# Santa Sophia Catholic College

Section 4.55(1A) Modification Application to  
SSD 9772

Catholic Education Diocese of Parramatta

September 2020

Figure 3-1 Proposed driveway to Fontana Drive

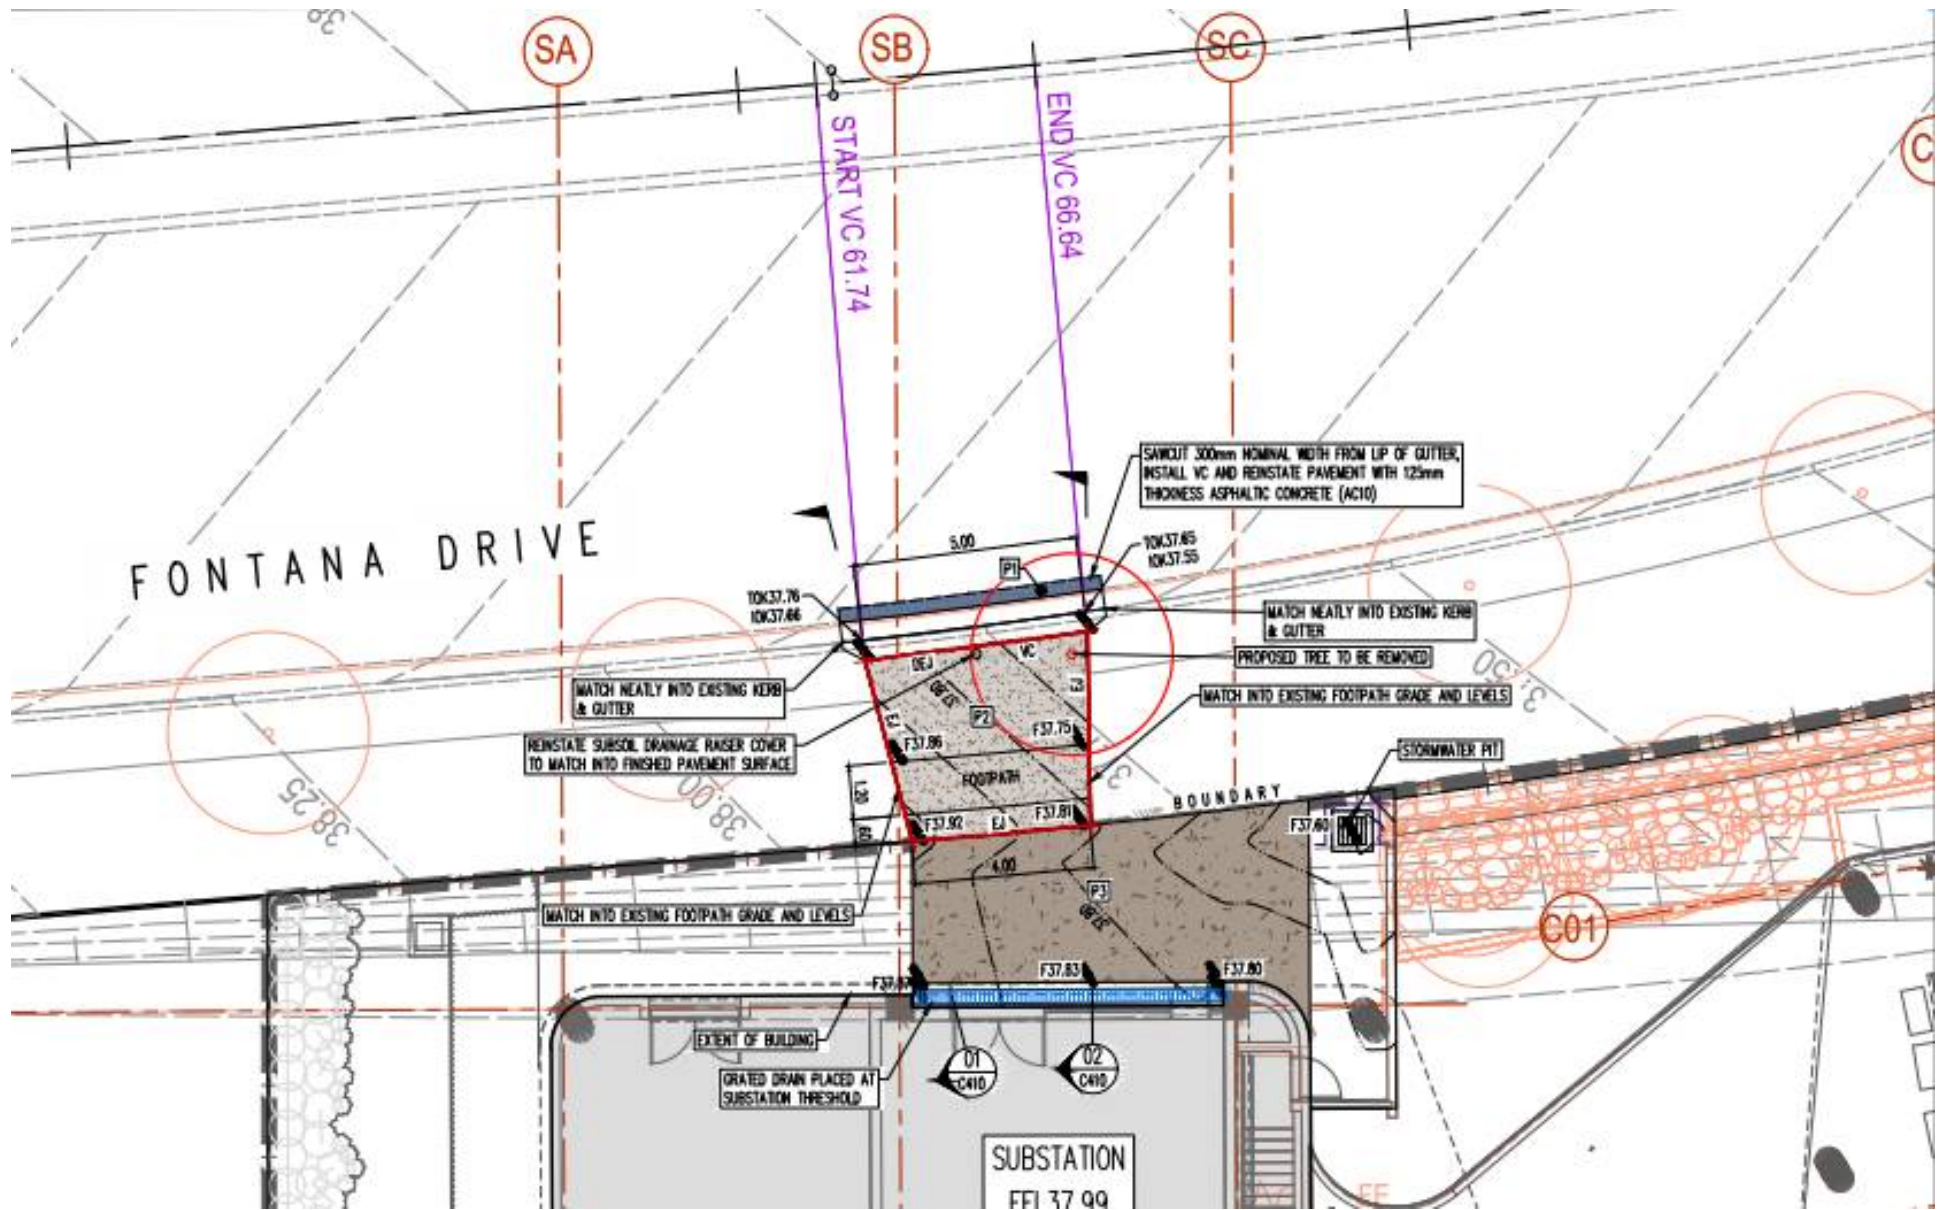
- The construction of a concrete pavement entrance from Fontana Drive approximately 4 to 5 metres wide and 5 metres deep to the school boundary. It is understood the Fontana Drive driveway is required by the electrical authority to access the substation from Fontana Drive.
- The construction of a concrete pavement entrance from Future Road B approximately 3.5 metres wide and 7 metres deep to the school boundary. It is understood the Future Road B driveway is required as a maintenance access for servicing and maintenance purposes.
- Provision of kerb and guttering for the access driveways.

The driveway and associated hardstand area have been designed to comply with Endeavour Energy standards. The driveway needs to be aligned with the roller door to the substation so that the transformer can be unloaded directly into the substation. The truck, which is approximately 10.5 metres long, will need to reverse from Fontana Drive into the driveway (refer to Drawing C430). During loading / unloading of the transformer the truck will be parked across the footpath and protrude into the parking lane of Fontana Drive.

Fontana Drive will have a medium strip which will prevent trucks turning right to exit from the driveway. When turning left to exit the site, the truck will have approximately 50-metre sight line to on-coming traffic.

The driveways will be constructed in accordance with Council's Driveway Specifications. The driveway to Fontana Drive will have a 3.7% to 3.9% fall from the boundary to the street gutter. The hardstand within the school boundary, which will be used for parking of electrical authority vehicle when they access the substation, will have 1.1% from the boundary to a grated drain in front of the school building. The driveway to Future Road B will have a 4% to 5% fall from the school boundary to the street gutter.

Figure 3-2 Proposed driveway to Future Road B

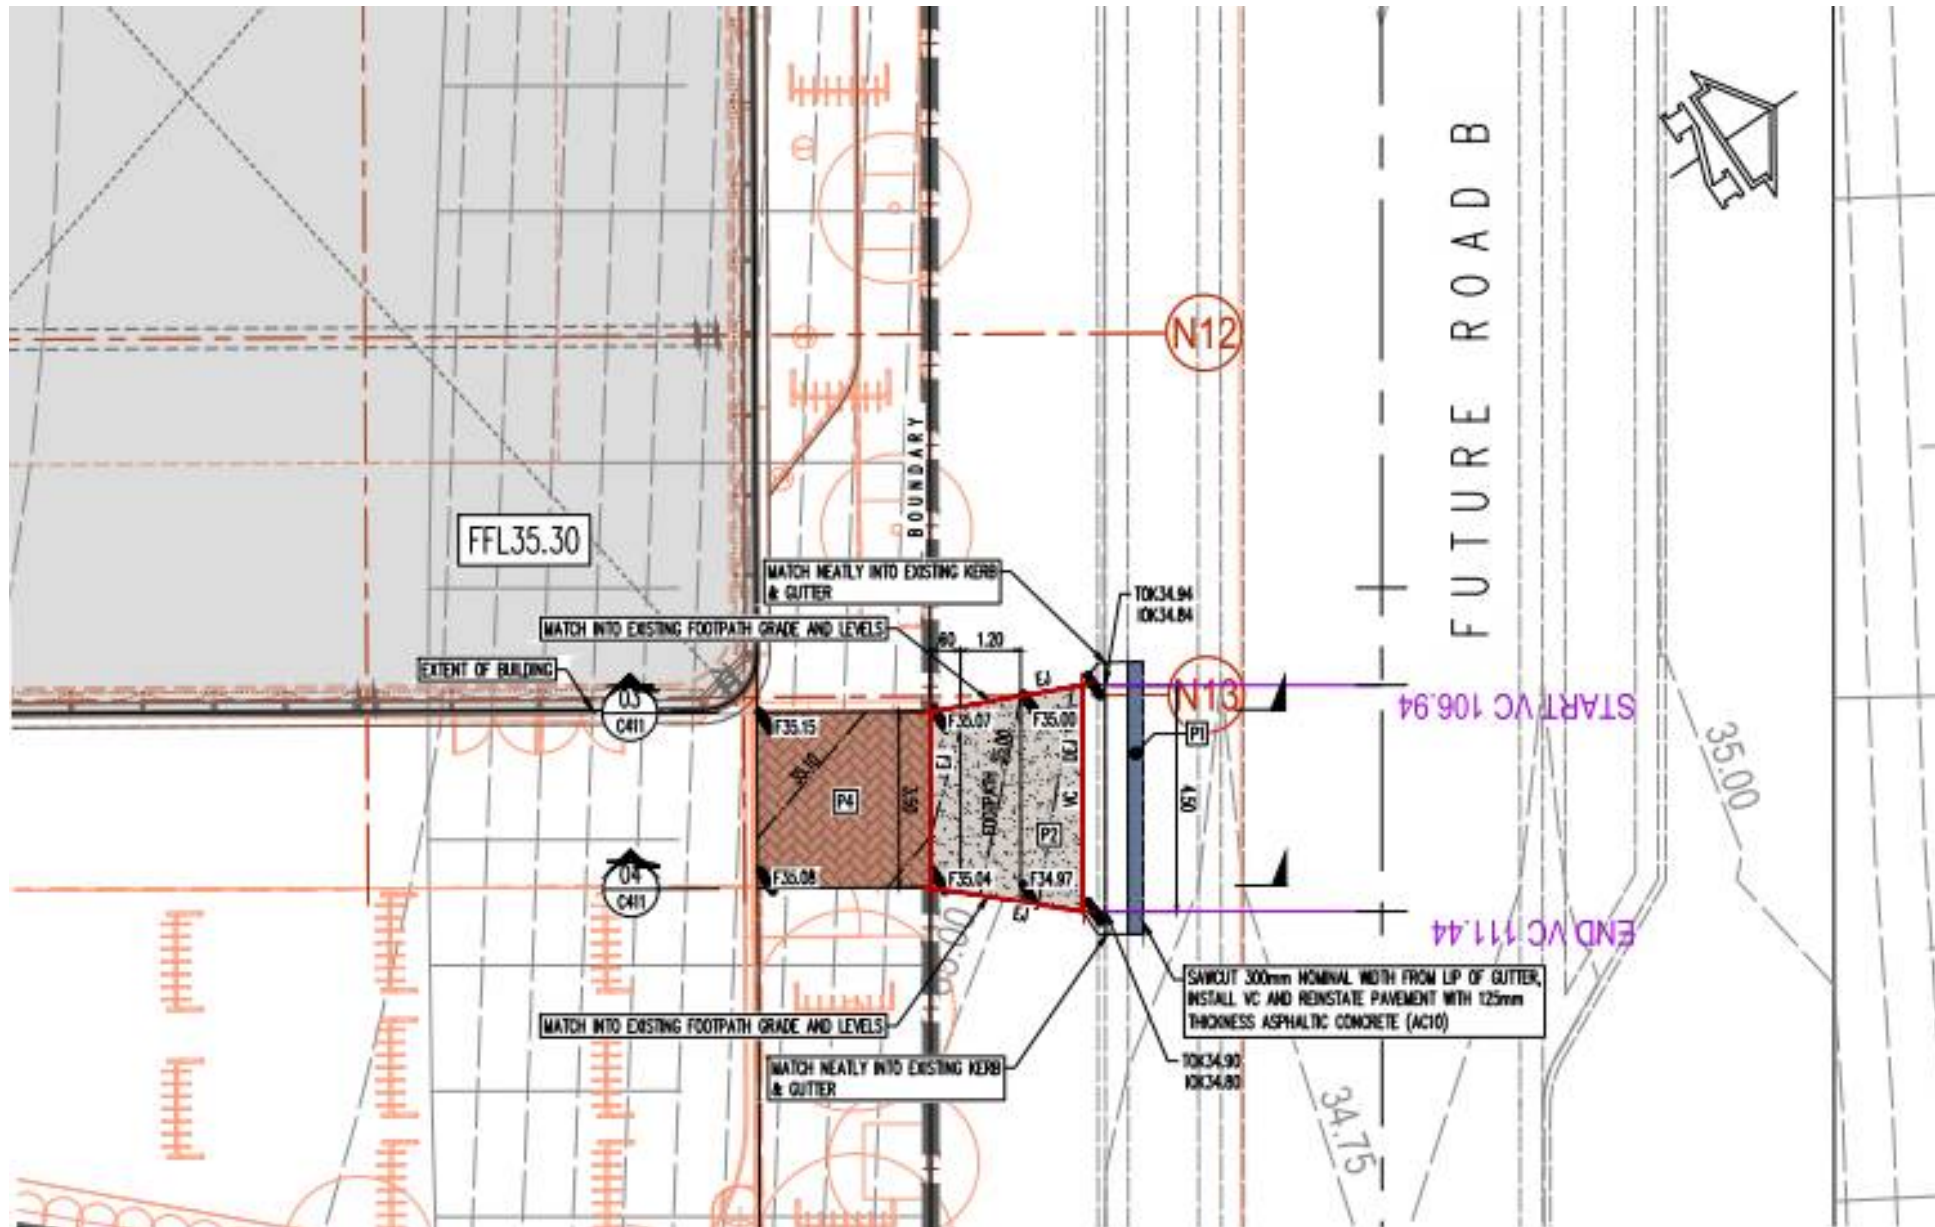
The Future Road B driveway will be accessed by utility vehicles and possibly light commercial vehicles. Vehicles will be able to use the forecourt of the Knowledge Centre and turn around to exit the site in a forward direction. Vehicles will be able enter and exit the site by turning left or right. Vehicles will have approximately 90-metre sight line to the intersection with Future Road B and Fontana Drive.
